# Access Compliance Report

## Public Rights-of-Way

### (Curb Ramps)

Intersection ID: 30240	Main Street: OLD_PLANK_RD	Cross Street: MCGINN GROVE DR	Location: SE
ADA ID: 48726CFE1B5A	Ramp Type: Perp	Initial Pass/Fail: Fail	Overall Compliance: No
Codes/Mitigation Info/Possible Solution		Field Measurements/Component Compliance	
Severity Score: 33.75

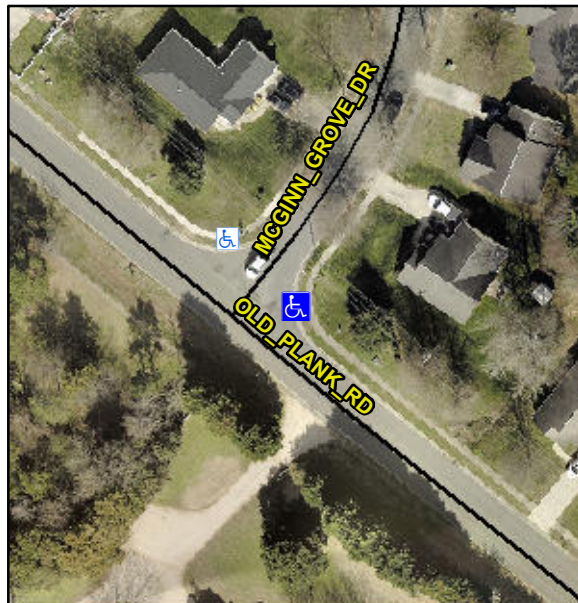
**Not Found, R304.5.1, R304.2.2, R304.5.3**

Compliance	Description	Data	Compliance	Description	Data
N/A	Ramp Length (in)	49.0	No	Ramp Slope (%)	11.6
No	Ramp Width (in)	42.5	No	Ramp XSlope (%)	6.4
N/A	Flare Type LT	N/A	N/A	Flare Type RT	N/A
N/A	Flare Slope LT (%)	N/A	N/A	Flare Slope RT (%)	N/A
N/A	Flare Traversable LT?	N/A	N/A	Flare Traversable RT?	N/A
N/A	Landing Length (in)	N/A	N/A	DWS Provided?	N/A
N/A	Landing Width (in)	N/A	N/A	DWS Contrast?	N/A
N/A	Landing Slope (%)	N/A	N/A	DWS Length (in)	N/A
N/A	Landing X Slope (%)	N/A	N/A	DWS Full Width?	N/A
N/A	Landing Curb? (Y/N)	N/A	N/A	DWS Offset (in)	N/A
N/A	Shared Landing?	N/A			
N/A	Gutter Ponding?	N/A	N/A	Gutter Slope (%)	N/A
N/A	Gutter Lip Ht (in)	N/A	N/A	Gutter X Slope (%)	N/A
N/A	Painted X Walk1?	No	N/A	Painted X Walk2?	N/A
	X Walk 1 Direction	To NW		X Walk 2 Direction	N/A
N/A	X Walk 1 Width (in)	N/A	N/A	X Walk 2 Width (in)	N/A
	X Walk 1 Slope (%)	2.7		X Walk 2 Slope (%)	N/A
	X Walk 1 X Slope (%)	7.1		X Walk 2 X Slope (%)	N/A

**Remove & Replace Entire Ramp.**
